Project Name: University of Wisconsin-La Crosse- New Student Fieldhouse & Soccer Support Facility (DFD 1512l)

Subject: Project Restart - DD Kickoff Meeting

10% Peer Review & Discussion – 15 Action Items & Recommendations

Windows, Control of Natural Light

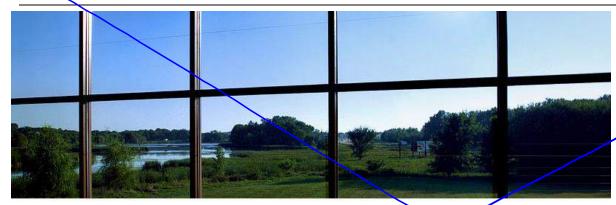
There were concerns about western exposure on this building. The review committee
felt the quality as well as quantity of light could be disadvantageous to athletic
activities. Design team will research energy efficient, tinted windows with
mechanical shades to provide lighting control.

- Windows, Control of Natural Light
 - a. Proceed with design using Frit Coated glass and interior window shades
 - b. No need to further consider Electronically Tainted Glass or Exterior Vertical Shades.

Below Grade Electrical

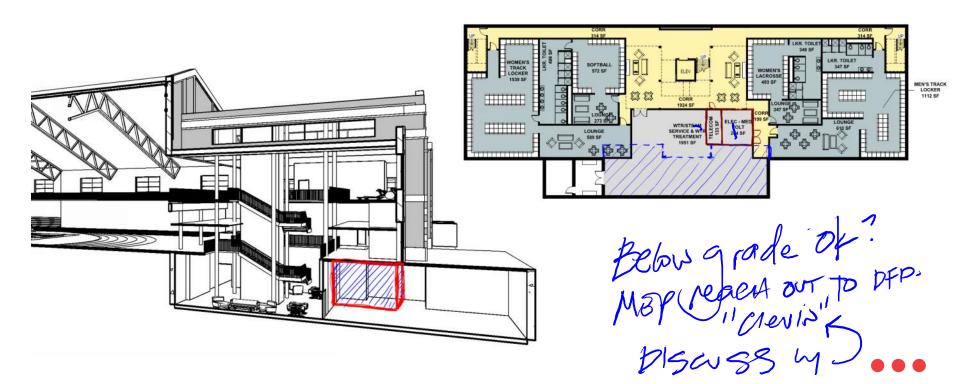
• Occupied space underneath the plaza is a potential problem in term of building budget and maintenance. There are more possibility for leaking/flooding. **Waterproofing** strategies needs to be researched. Move the electrical components.

- 2. Electrical below grade
 - a. The University does not object to below grade MEP, but have requested the A/E Team reach out to Clevin _____ (DFD) for his input on the location / acceptability of below grade Electrical Equipment.

Protecting Non-Spikable Flooring

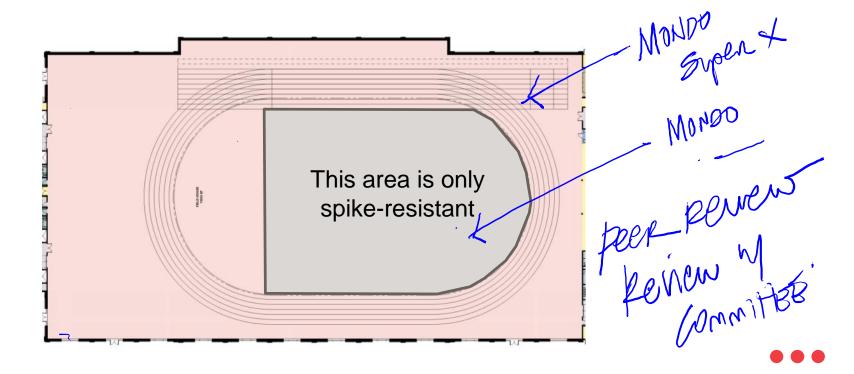
There were concerns about the separation of spikable and non-spikable athletic surfaces. Review committee were concerned that non spikable surface would be damaged by athlete's cleats without proper protection.

- Protecting non-spikable flooring
 - a. Materials that would work with rec sports activities and track activities?
 - i. Driver on this project is the indoor track programs...end of the day, so don't want to compromise track solutions for other activities.

- ii. Keep this on the table for discussion. Other installations/projects/products, for reference.
 - iii. Minnesota, Milwaukee, others.....for reference.

Showers in General Lockers

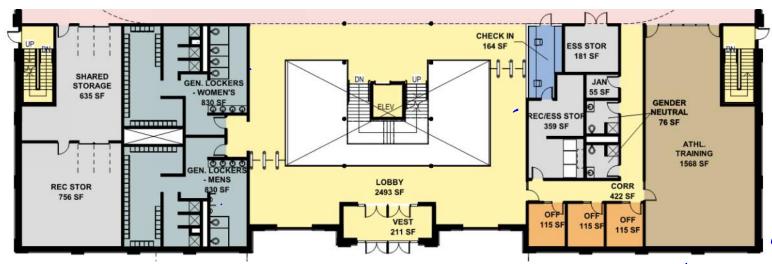
There were concerns about the south general use (main level) locker rooms and if the showers would get used. Review with user if the mix of lockers to showers is correct.

- 4. Showers in General Lockers
 - a. Will showers be used? RDG has seen a strong decline of shower use, but not elimination of these.
 - i. Campus perspective, OK as-is. We discussed with campus and determined that the showers, as shown, are necessary.

Acoustical Control

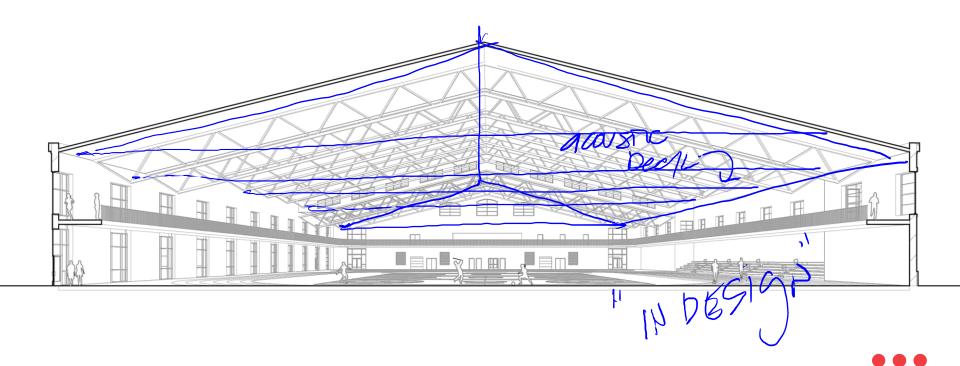
Acoustic control were a concern for an active, large open space. Design team are planning on using acoustical decking in the field house to absorb reverberation.

Review committee requested to see additional acoustic strategies.

- 5. Acoustical Control
 - a. Acoustical decking at roof deck
 - **b.** Currently in design, with an acoustical modeling and will generate a report.
 - c. Will keep moving forward with developing this.

FIELDHOUSE - ROOFING MATERIAL

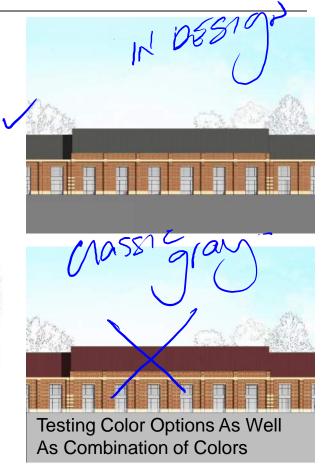
Review committee posed questions about roof materials. Roof can be seen from the football stadium as well as from Grandad bluff. Review committee suggested roof needed to be aesthetically pleasing texture/color while avoid glaring issues.

- 6. Roofing Materials
 - a. Controlling glare, from within the stadium
 - i. Roofing: RDG to reach out to the roofing individual at DFD, with one or two options, for review. Roofs for UWL are extremely sensitive. UWL / Beth to send through contact in the next day or two.

- ii. Color pretty surely not looking at the maroons etc. Nice standard, classic grays or similar.
- 7. Sliding Snow
 - a. Providing parapet, stopping the majority of this sliding snow, in combination with snow jacks. Hold so it will melt in place.

Sliding Snow

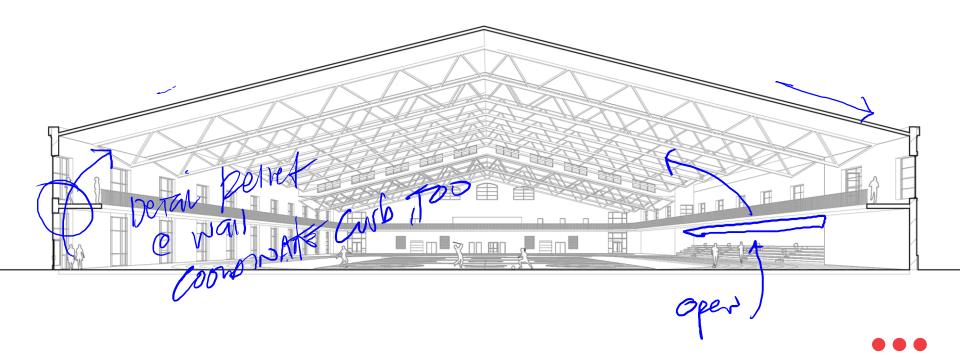
Review committee warned about the amount of snow that will be collected on large roof area during winter months. Falling snow and ice needs to be taken into consideration, especially for the pedestrian path along West side of building.

Multiple Entrances, Large Events

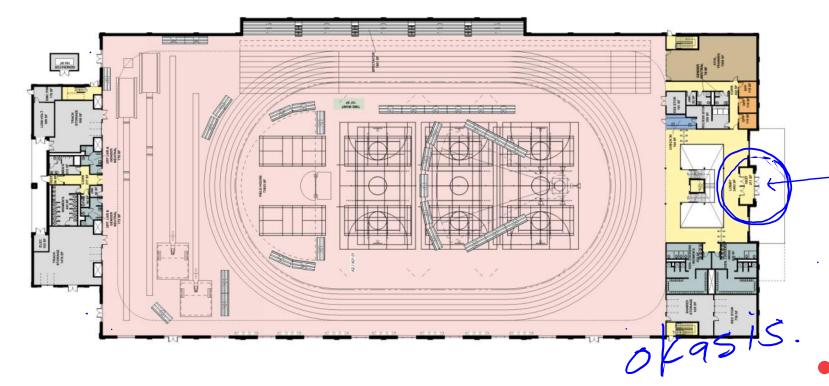
Review committee had questions about flow of vehicular and pedestrian traffic on site during large events. Committee suggested having more than one entrance for large events.

- 10. Multiple Entrances, Large Events
 - a. Should there be more than one, main entrance?
 - i. 'NO'. Primary entrance to the south, with two large garage doors at west, with several doors at North that could be opened as well. All controlled through security. Will be managed like a rec center during the day, so one main entrance seems to work the best.

Storm Water Management

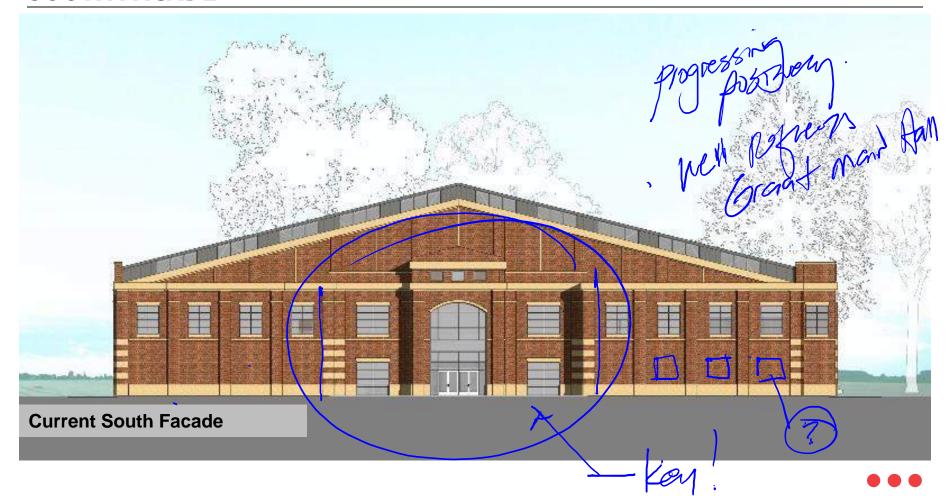
Storm water retention strategies needs further development.

- **a.** We know where the impact is. Existing impervious area helps, and have underground detention currently in the project. Reviewing this is an immediate next step.

South Façade, more Exciting

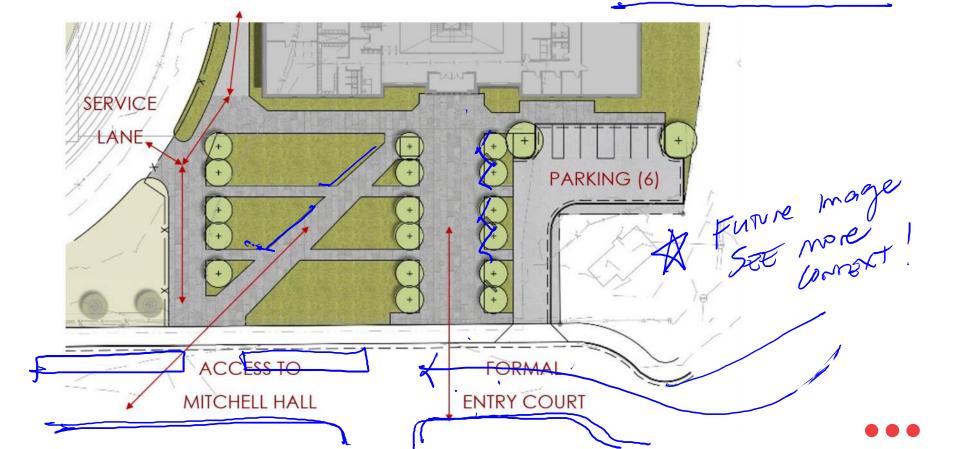
- 13
- Review committee noted the design of the south façade needed more experimentations with proportions and brick / cast stone ratio. The façade needed to be even more inviting for students and campus.
- East façade was not discussed during presentation and needs further refinement in regards to being the new east edge of campus.

- i. Showed South and East as currently designed. Had direction to design with traditional approach. Will continue working through design, with material ratios. Glazing not as much, in regards to transparency. Will dig into masonry detailing...

- 1. The blend is not something that they would embrace.... Window profiles mullion positioning / division etc..
 - Upper part of the structure, regarding brick detailing, is very traditional and collegiate. Developing nicely.

- 3. Wonderful reflection of Gratt Main Hall, at the south façade.
 - 4. Anything we can do to make the entrance stand out or be more recognizable, with no confusion as to how you enter the building. Challenge is that no areas on the first floor require and warrant exterior fenestrations. Spandrel glass into these spaces potentially?

WEST FACADE

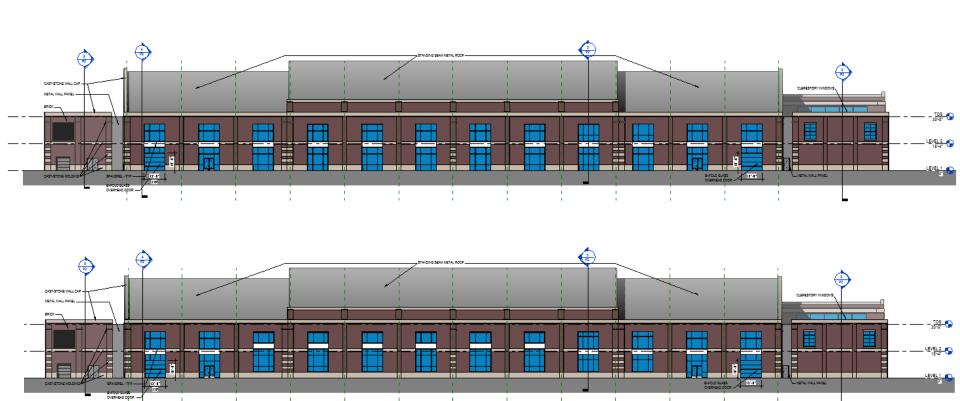
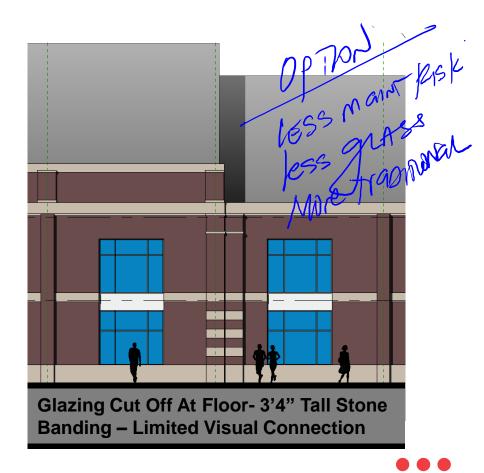
• Glass near floor levels and both 1st and 2nd floor is a concern in term of impact and maintenance.

- 15. Impact resistance for glass
 - a. Showed current west façade, with glass to the ground. Showed an alternative with glass pulled up 3'-0" from ground plane.

- i. More traditional, like the glass pulled up and design should proceed as such. Reduces glass and puts us closer to the 22% preference. Both design wise and functionally, pulling this up seems stronger.

1 | Fieldhouse - Field Events

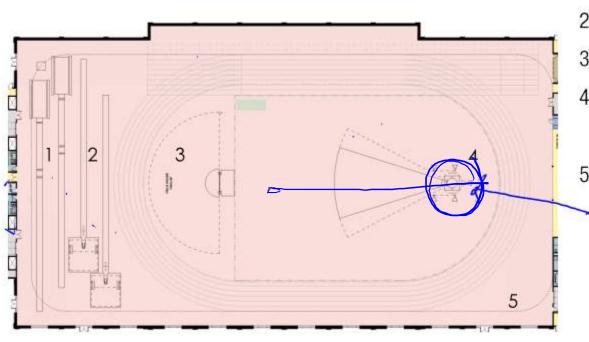
Removable floor plate for in-floor throw circle

1 | Fieldhouse - Spectator Seating

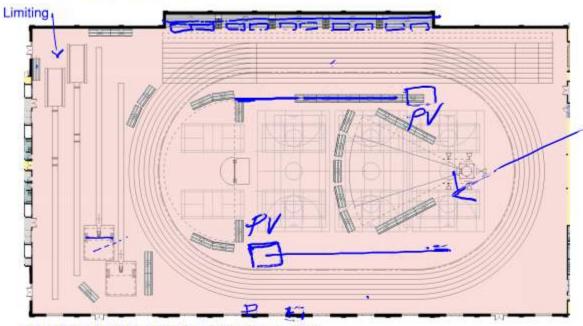
Might be too tight. Might need space in this area for 120 -150 persons (80 Athletes, and Officials)

- 1,500 SPECTATOR SEATS
 - 940 TILT 'N ROLL BLEACHERS
 - 560 RETRACTABLE BLEACHERS
 - Confirm storage for Bleachers and Tilt-n-Roll
